## AGENDA - LPP

| <b>Meeting:</b>       | Georges River Local Planning Panel (LPP)   |
| <b>Date:</b>          | Thursday, 19 November 2020   |

**REPORT TO GEORGES RIVER COUNCIL  
LPP MEETING OF THURSDAY, 19 NOVEMBER 2020**

**Figure 5** – Extract of amended cross section illustrating the proposed lift overrun and communal area over 15m Height of Building with a maximum height of 18.49m (+3.49m) (Source: D R Designs (NSW) Pty Ltd, 2020).

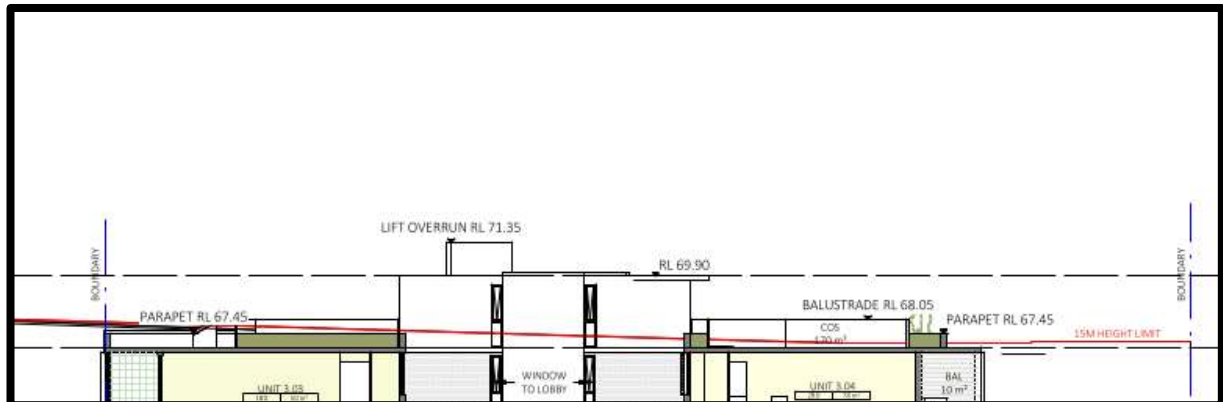
15. The proposal seeks a variation to Clause 4.3 Height of Building which prescribes a 15m height limit for this site under Hurstville Local Environmental Plan 2012. The extent of the variation relates to the lift overrun, roofed communal open space and balustrades proposing a maximum height of 18.49m for the lift overrun being a variation of 3.49m equating to 23.26%. A Clause 4.6 Exception to Development Standard statement accompanies the development application however this does not accurately reflect the

extent of the variation sought. The amended proposal has resulted in additional breaches associated with the balustrades for the front portion of the communal open space area however this has not resulted in a greater maximum breach than that originally proposed. An amended Clause 4.6 Exception to Development Standard was not provided in support of the amended proposal. An assessment has been undertaken based on the submitted Clause 4.6 Exception to Development Standard. Notwithstanding, the extent of the breach above 15m for the lift overrun and communal space is considered to be excessive, unnecessary and insufficiently justified and therefore is not supported.

**Figure 6** – Extract of ground floor and street interface to The Avenue, Hurstville (Source: D R Designs (NSW) Pty Ltd, 2020).

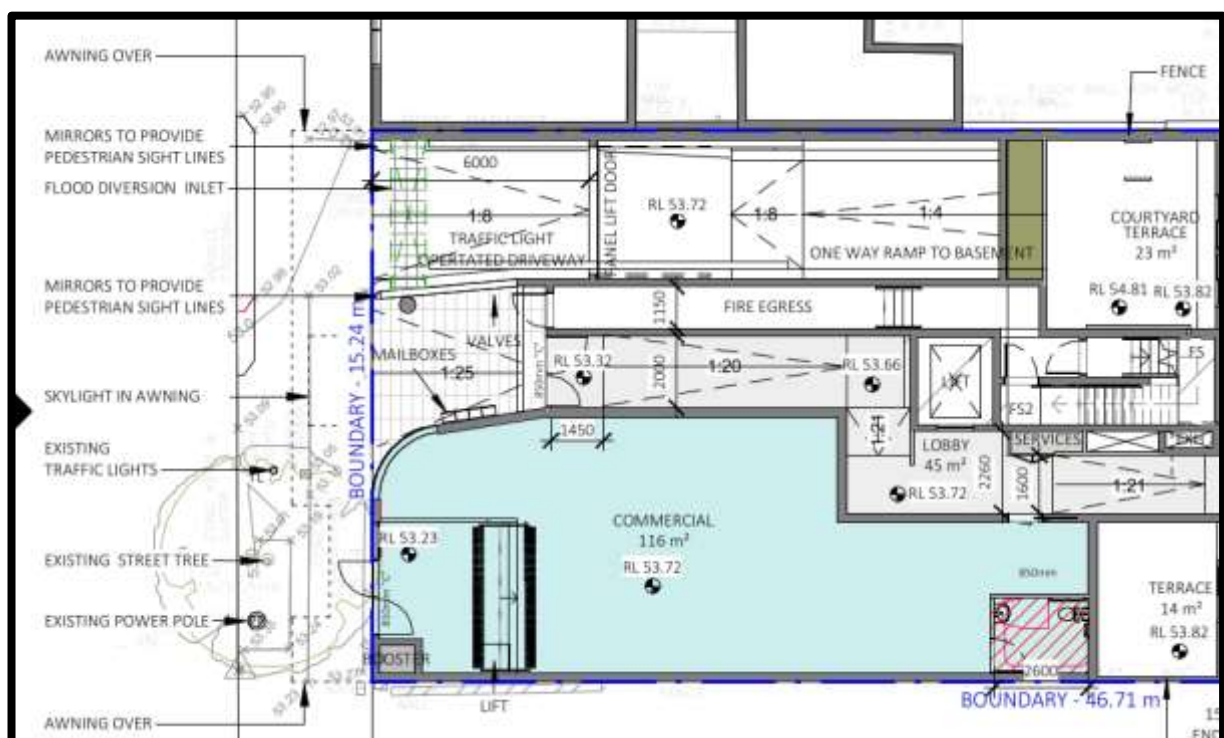
16. The proposal fails to satisfy Clause 6.6 Active Street Frontages of the Hurstville Local Environmental Plan 2012 where the objective of this clause is *“to promote uses that attract pedestrian traffic along certain ground floor street frontages in Zone B2 Local Centre, Zone B3 Commercial Core and Zone B4 Mixed Use”*. Due to the narrow allotment width and floor plate proposed, the design results in a poor quality active street frontage.

**Figure 12:** Extract of amended cross section demonstrating extent of non-compliance above 15m whereby the upper element of the communal open space, balustrades and lift overrun (RL 71.35) exceed the height of building (Source: D R Designs (NSW) Pty Ltd, 2020)

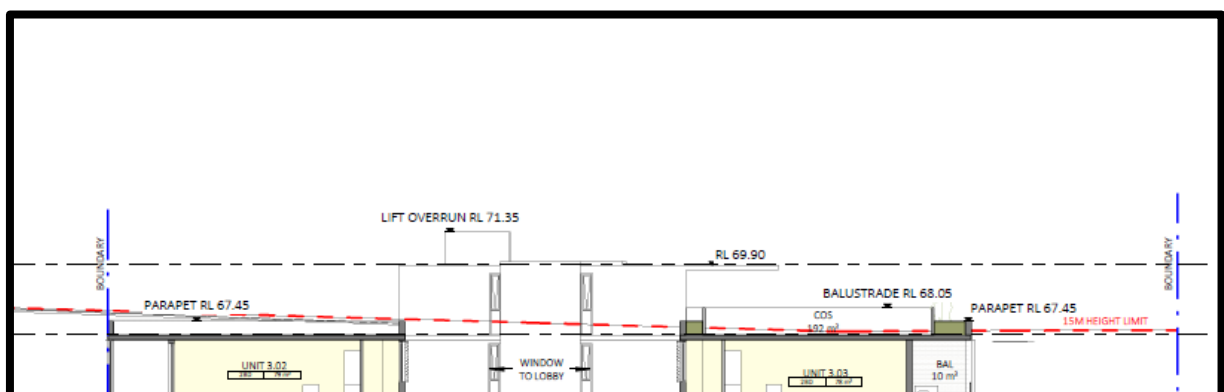
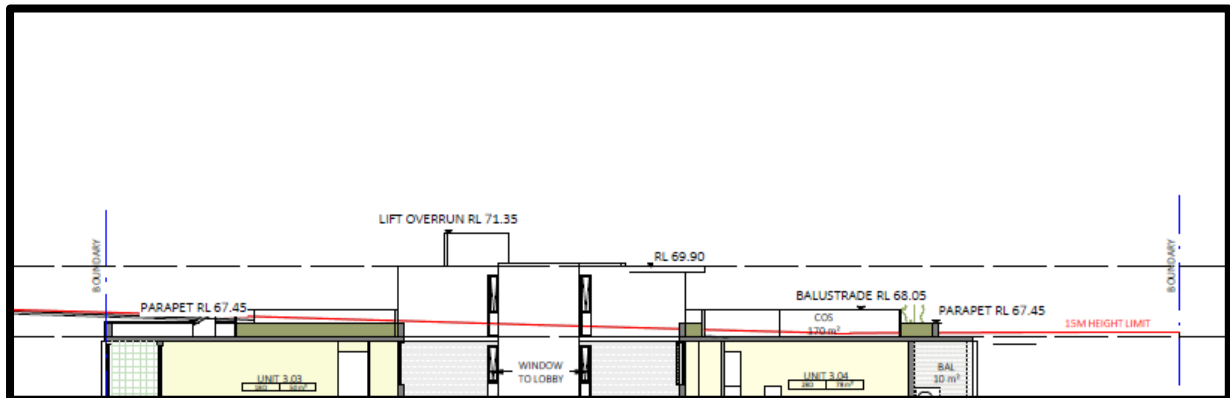
83. Council's assessment indicates the extent of the non-compliance is an additional 700mm, at the highest point being the top of the lift over-run at RL71.35 being 18.49m (+3.49m or 23.26%) above the 15m height limit, with which the applicants Clause 4.6 Exception to Development Standard statement does not align.
84. In support of the non-compliance, the applicant has provided a request for a variation to Clause 4.3 in accordance with Clause 4.6 of Hurstville Local Environmental Plan 2012 (LEP) for the variation sought, of which points have been extracted justify the reasons in supporting the variation. This Clause 4.6 request for variation is assessed as follows.

95. Officer Comment: The applicant's justification is not supported. As shown in the cross section (Figure 12), the extent of the height variation relates to balustrades, communal roof top area and lift overrun. The proposed variation does comprise of floor space which has been included within this assessment.
